**ACI COMMITTEE 437
STRENGTH EVALUATION OF EXISTING CONCRETE STRUCTURES**

**Main Committee Meeting
2011 ACI Fall Convention – Cincinnati, Ohio
17 October 2011, 10:30 am - 12:30 pm
Duke Energy Center – Room 202**

MEETING MINUTES

7.2 **Task Group: Code Requirements and Commentary for Load Testing of Existing Concrete Structures**

Page 23, Line 6-8

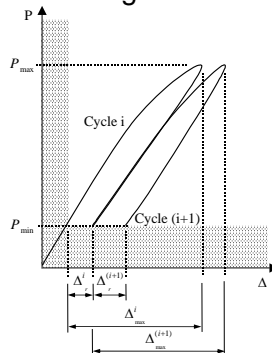
Comment No. 12

The figure shall be replaced with the following:

Larosche: Negative withdrawn by Galati
<u>Action:</u>
No vote required
Vote Count: Affirmative:-- Negative:-- Abstain:--
No vote
